Memorandum

DATE: May 12, 2015

SUBJECT: FMBZA 19013 –Application of the Apostolic Nuncio of the Holy See, pursuant to 11DCMR § 1002 and §206 of the Foreign Missions Act

Attachment II – Potential Alternative Fence Location

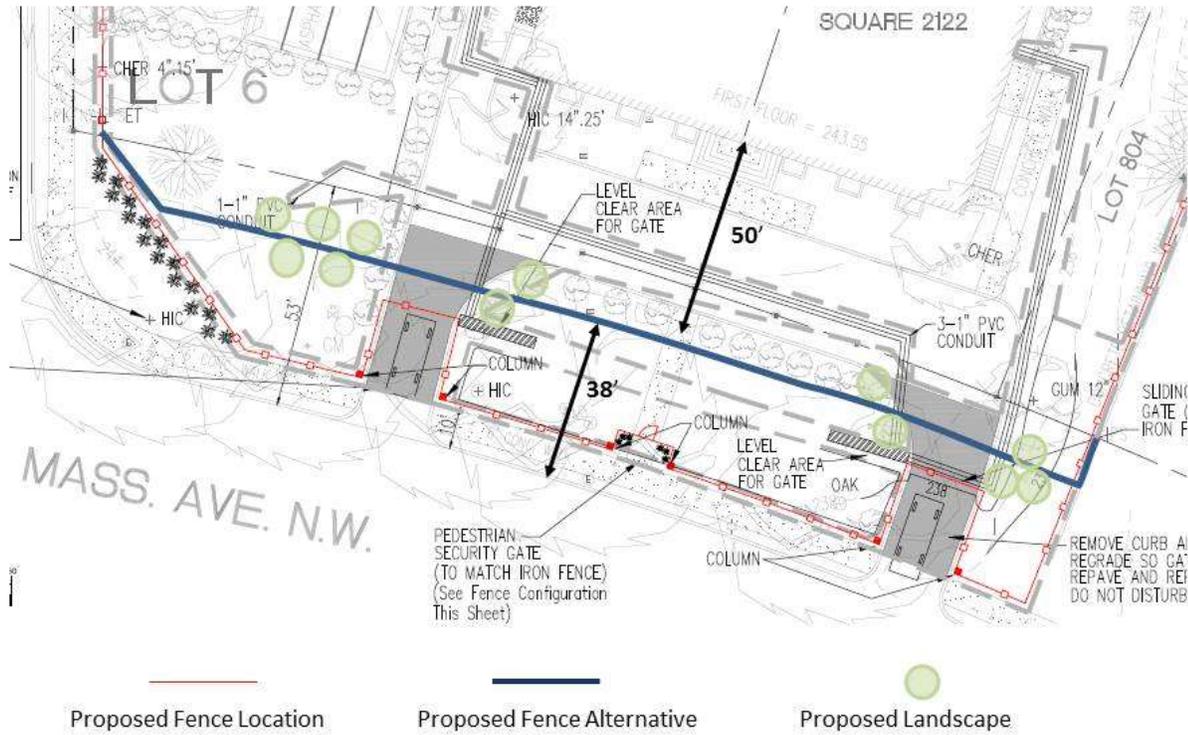
located three feet from the back of the sidewalk, behind hedges, and within a building restriction area. Along Massachusetts Avenue, the fence is proposed to be in public space. The fence's visual impact along Massachusetts Avenue, where the embassy is set back more than 80 feet from the curb, is notable. In this location, the fence impacts the view corridor along the Avenue, where it is proposed to be eighteen inches from the back of the sidewalk. While the fence along 34th Street also requires a waiver from regulations, its location behind landscaping mitigates its impact on public space.

The proposed security buffer (the distance between the proposed fence and the building) along Massachusetts Avenue also exceeds the 50-foot security setback for Level IV facilities, recommended by the U.S. Department of Homeland Security's Interagency Security Committee (ISC) and adopted in August 2013.⁴ Foreign embassies and consulates in the United States are identified as Level IV facilities. The embassy main building is 35 feet from the property line and more than 80 feet from the curb, leaving a generous amount of set back from the building to where a security fence providing the security buffer could be located. A security fence pulled back closer to the property line, as far as 38 feet from the curb, would maintain the 50 distance from the embassy and be more consistent with the intent of public space regulations - see alternative fence location, Attachment III, developed by OP Staff. Historic Preservation Review staff indicated that they do not object to the alternative location. OP contacted the representative of the applicant to request a meeting to discuss the alternative, but the request was declined.

The Department of Transportation's Urban Forestry Administration reviewed the application and recommends that, to ensure the health of the trees in public space, the fence along Massachusetts Avenue should be relocated as far from existing trees as possible, a location that is more consistent with the one being recommended by the Office of Planning.

The Office of Planning, therefore, has no concerns with the proposed design, materials, or height of the proposed security fence and gates, but concludes that it would be made more consistent with District interests in maintaining the open character along Massachusetts Avenue and maintaining the health of street trees by placing the fence up to 38 feet back from the curb. This would also satisfy U.S. Department of Homeland Security criteria and embassy needs for the standard 50 foot security buffer between the fence and the building.
